**FINAL ARCHITECTURAL HERITAGE IMPACT ASSESSMENT OF  
PROPOSED DEVELOPMENT OF HOLY CROSS COLLEGE LANDS,  
CLONLIFFE ROAD, DUBLIN 3 (INCLUDING PROTECTED  
STRUCTURES)**

*Figure 1: Extract from the 1875-89 Ordnance Survey Map showing the extents of the College Lands at this time and the relationship to Clonliffe House (now the Red House).*

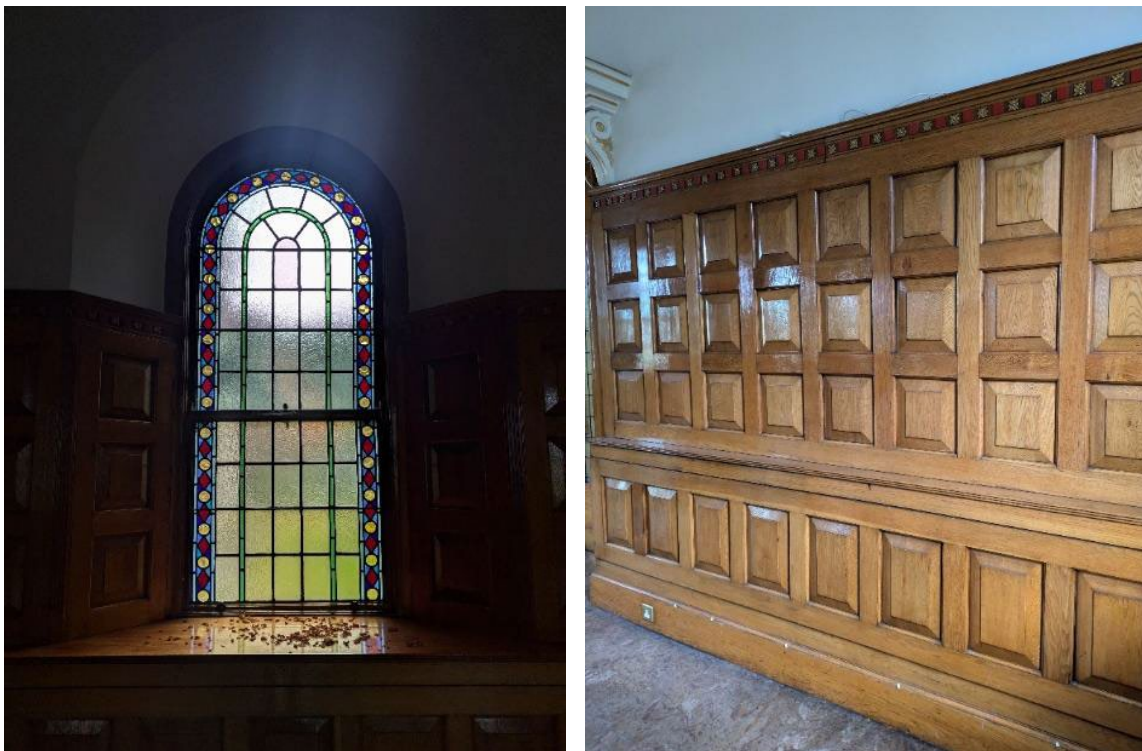
Architectural significance can be ascribed to the building on the basis of its arcade forming the northern edge of the cloistered, formal College quadrangle, and the contribution that it makes to the character of the quadrangle. The architectural language of the arcade on the southern elevation of the building was replicated in the later ambulatory, and together these features frame the quadrangle to the rear of the main Seminary block and contribute to the architectural character of the quadrangle. This element - *"the single storey arcade forming northern perimeter of college quadrangle"* - , whilst not inscribed in accordance with the Act, has nevertheless been 'clarified' within the most recent Development Plan as being protected due to it forming the northern part of the later Ambulatory Protected Structure. It is worth noting that the remainder of the building has not been included through such clarification and that the 1960s Oratory fit-out is omitted also.
